Addendum No. 03

September 11, 2025

SUCF Project No. 221038-00

Renovate Pioneer Center

SANITARY SEWER PROFILE

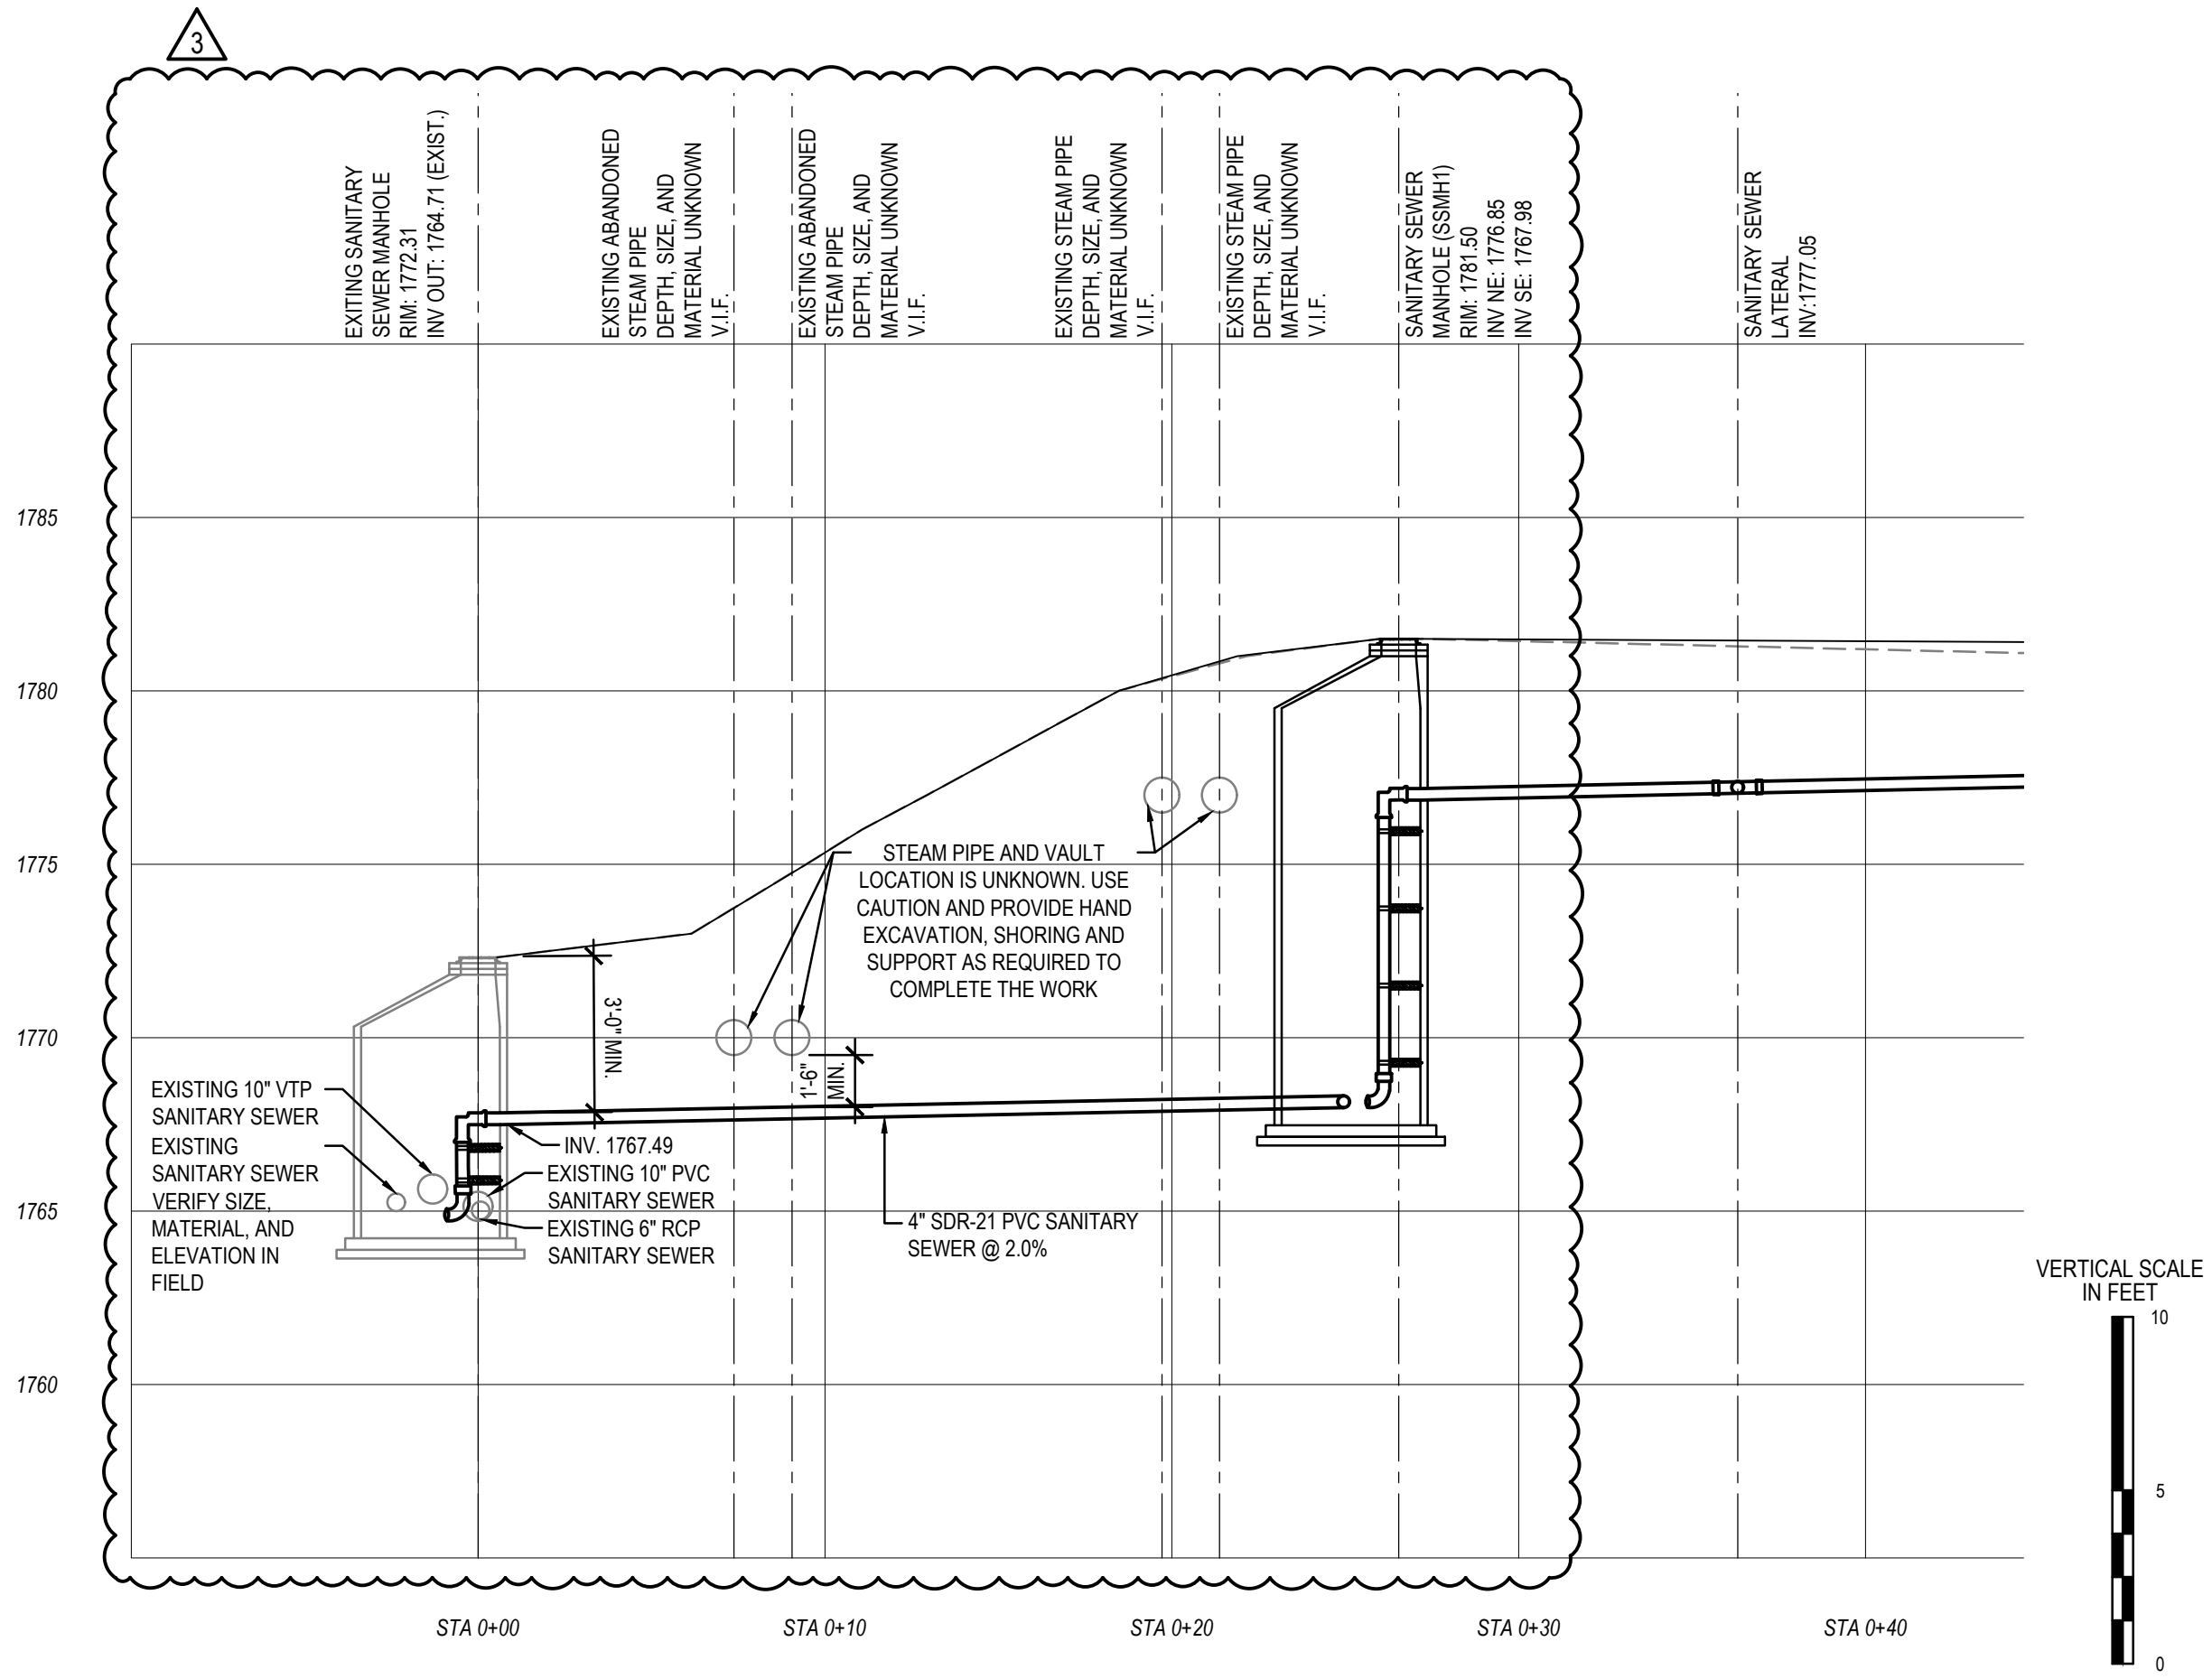
Revise: Sanitary Sewer Profile 2/C-302 as indicated on drawing CSK-016.

INSIDE DROP PIPE

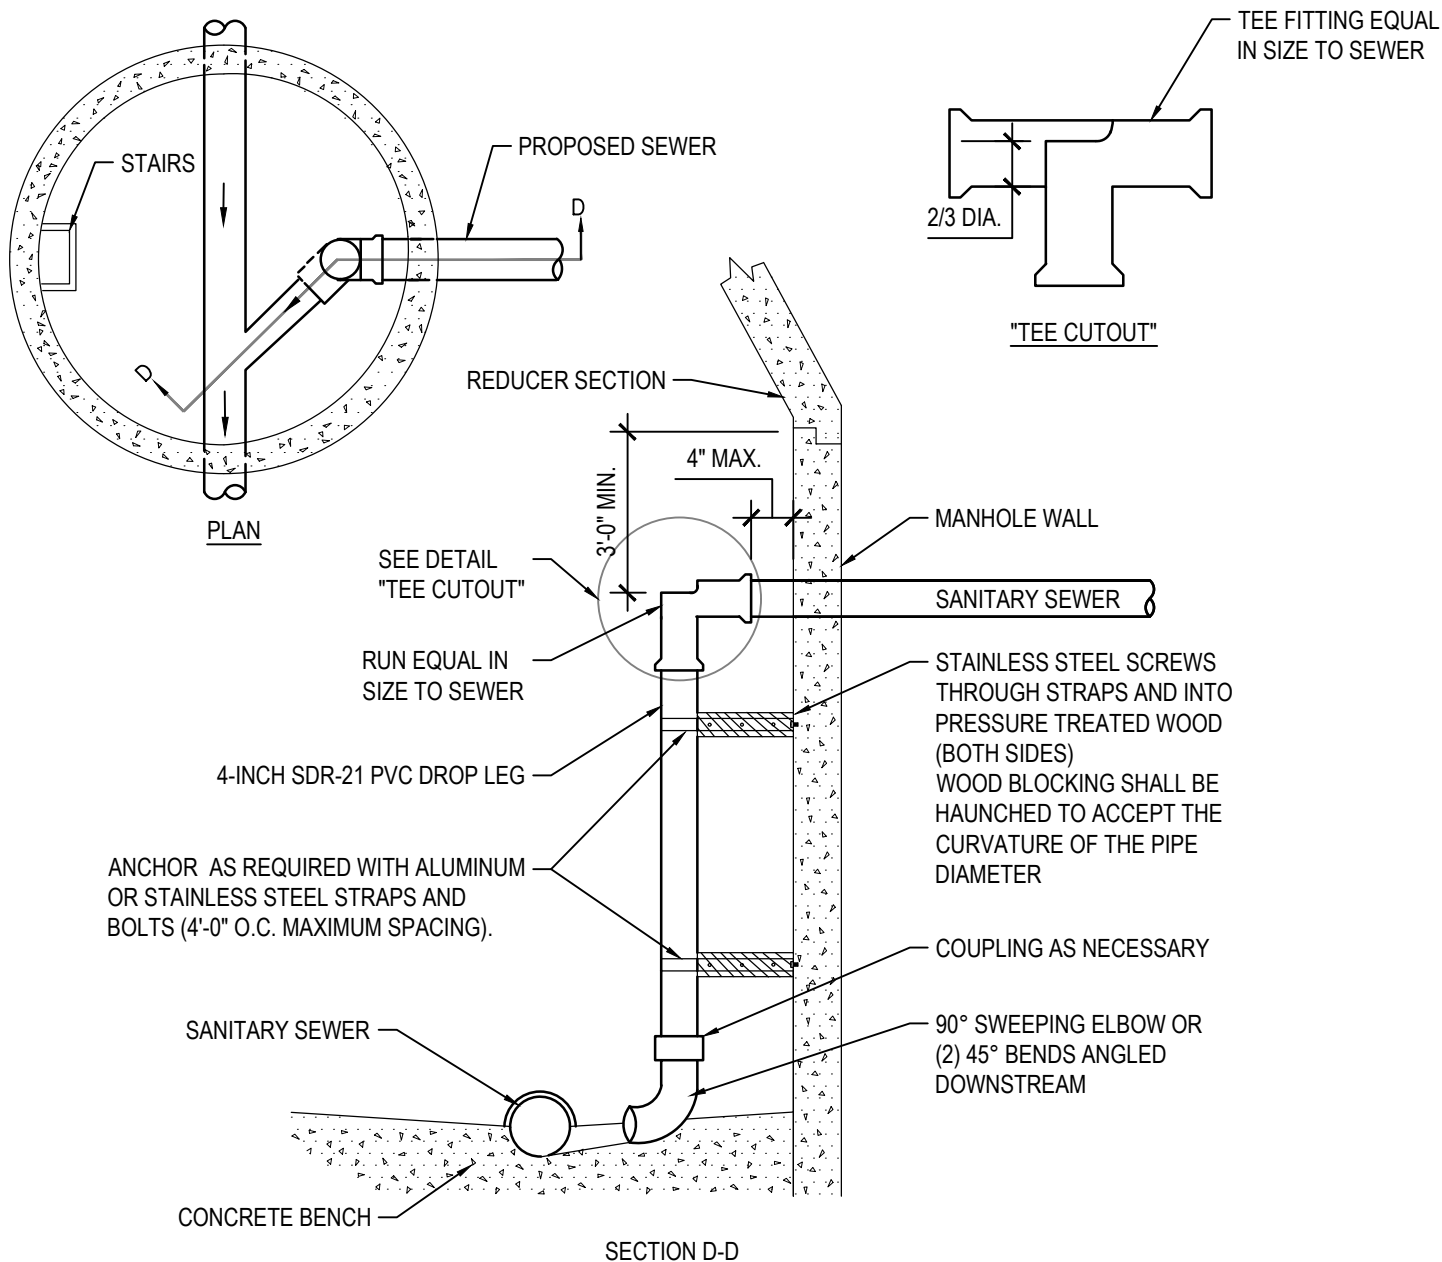
- Add:** Inside Drop Pipe detail 9/C-504 as indicated on drawing CSK-018

1. A DROP PIPE SHALL BE PROVIDED FOR A SEWER ENTERING A MANHOLE AT AN ELEVATION OF 24 INCHES OR MORE ABOVE THE MANHOLE INVERT. ONLY INSIDE DROP ASSEMBLIES WILL BE ALLOWED.
2. INSIDE DROP LEG SHALL BE INSTALLED ON MANHOLE WALL LOCATED AS SHOWN OR AS APPROVED.
3. ON NEW CONSTRUCTION INSIDE DROP ASSEMBLIES SHALL BE INSTALLED IN MANHOLES NOT LESS THAN 5'-0" IN DIAMETER.
4. PROVIDE INSIDE DROP PIPE AT LOCATIONS INDICATED "PROVIDE INTERNAL DROP LEG" ON C-142.

TYPICAL EXTERIOR EQUIPMENT PAD DETAIL
N.T.S.

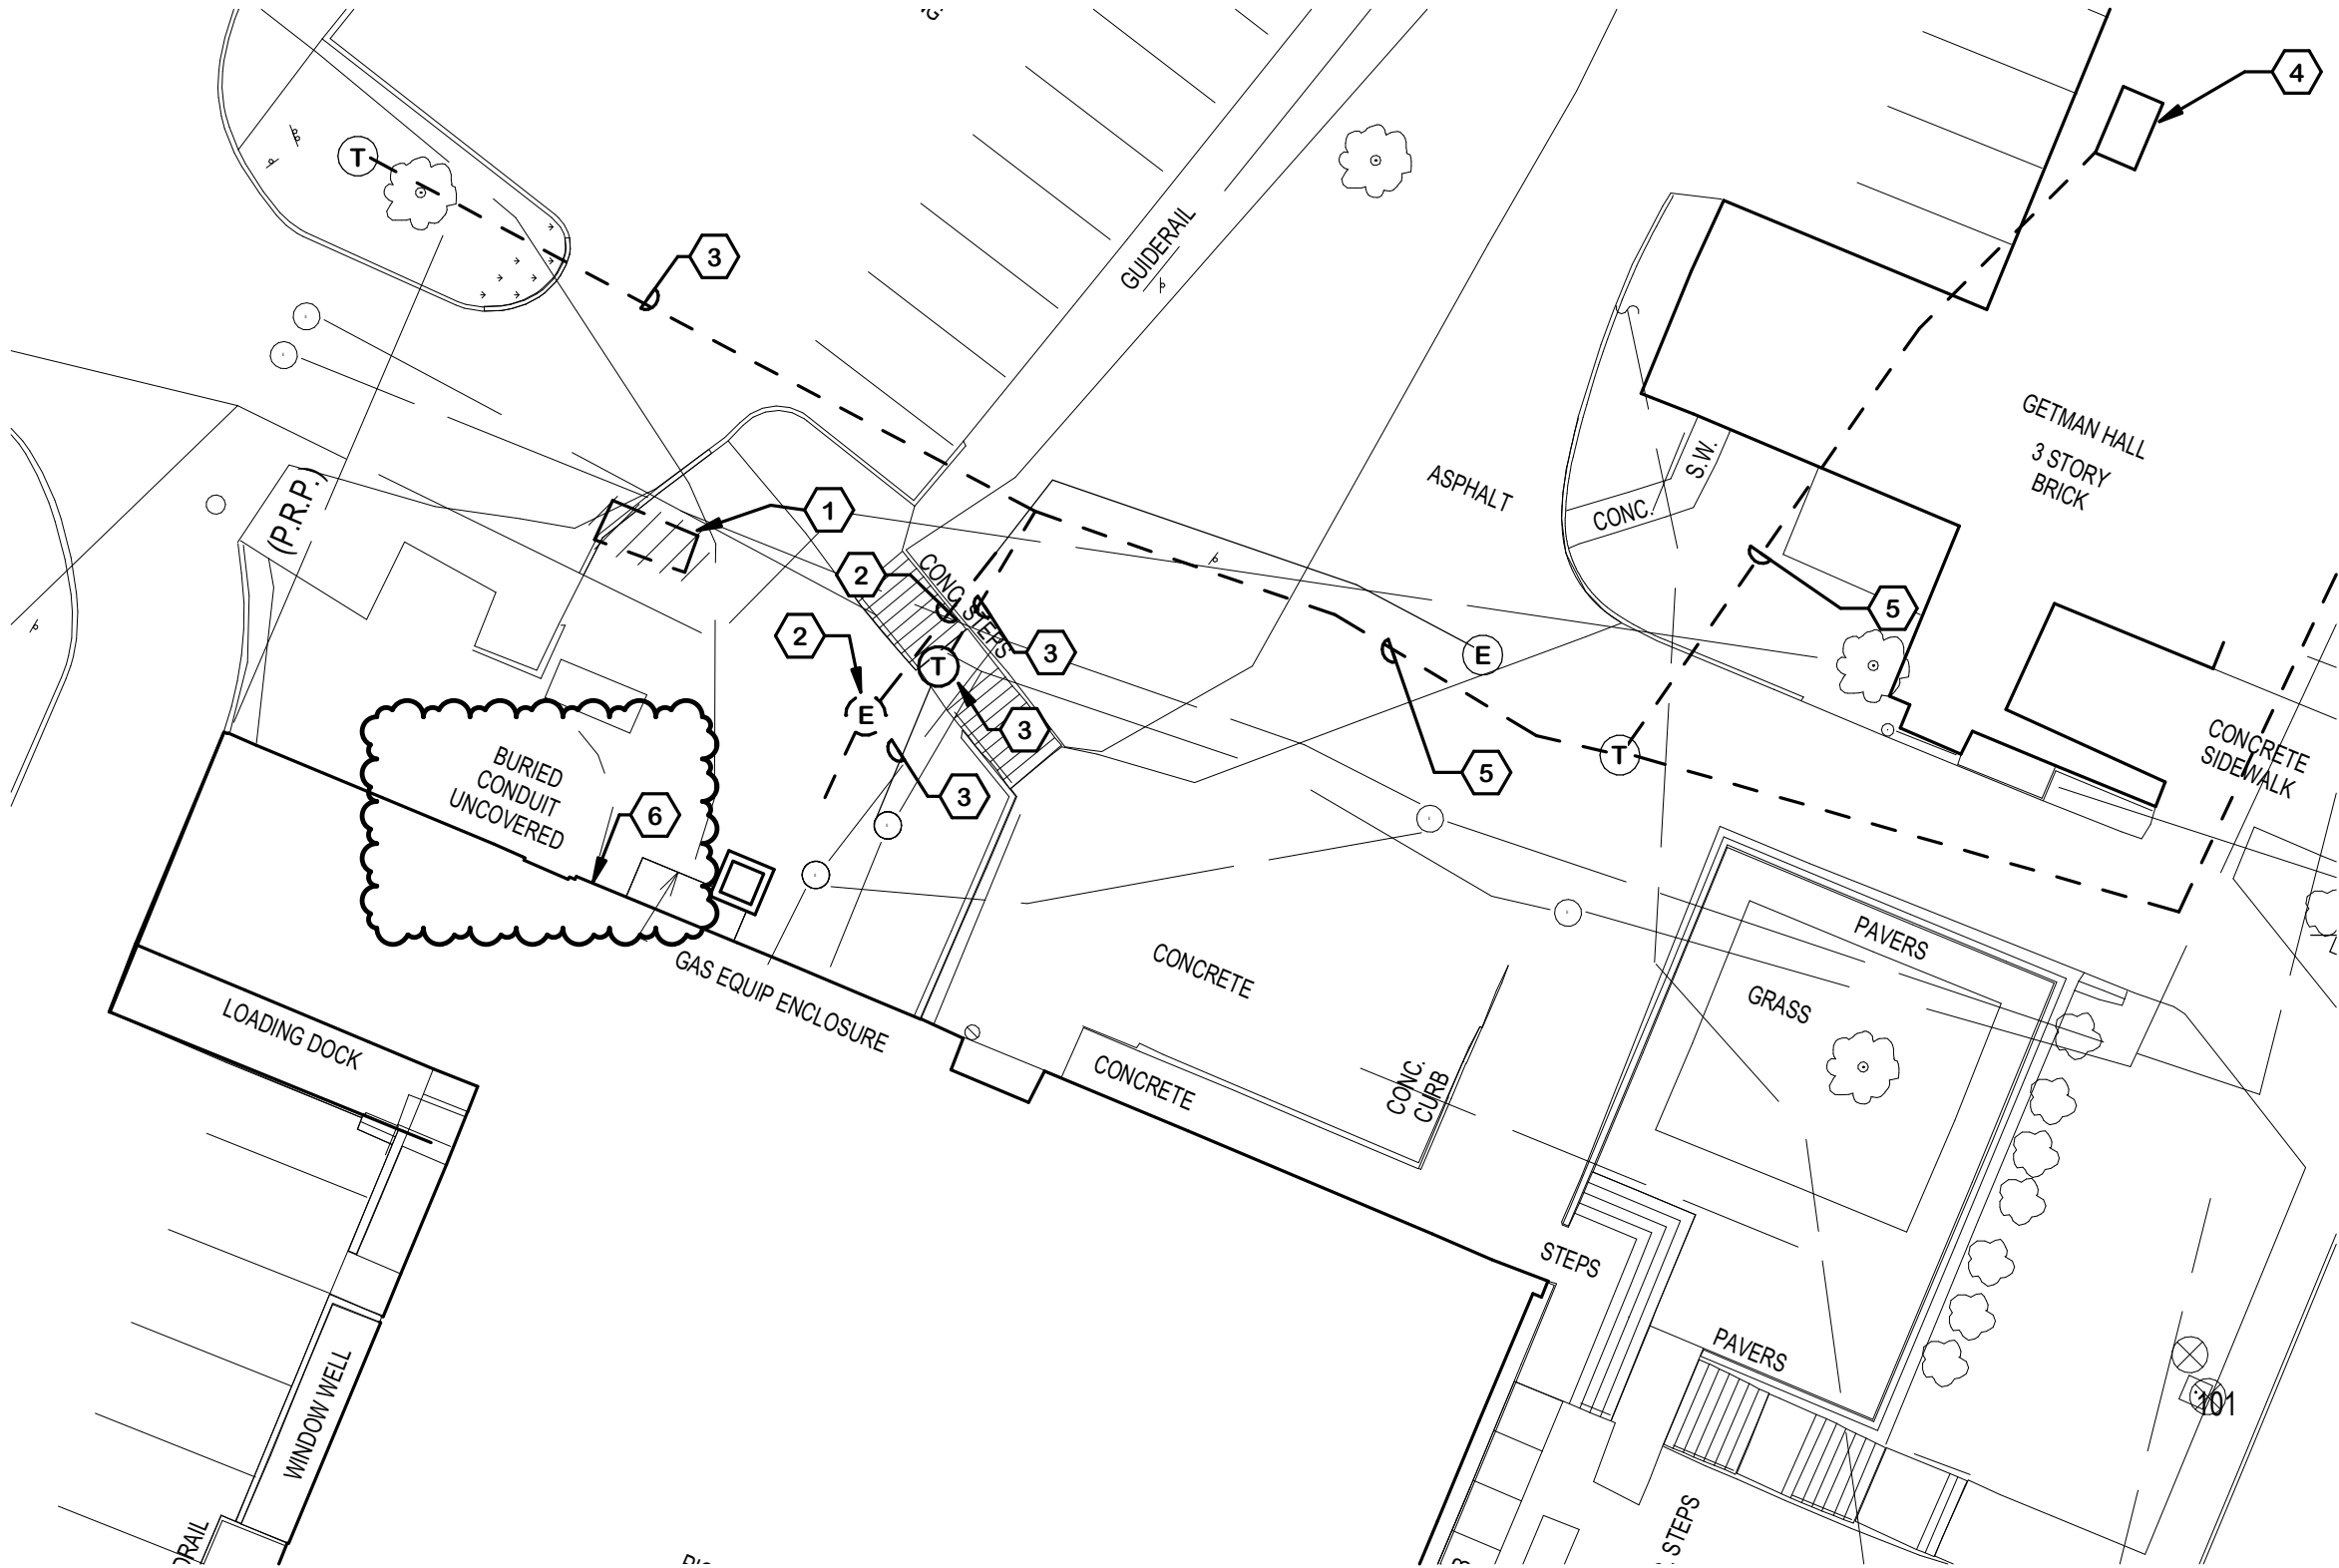
- Revise:** Typical Exterior Equipment Pad detail 12/S-701 as indicated on drawing SSK-001.
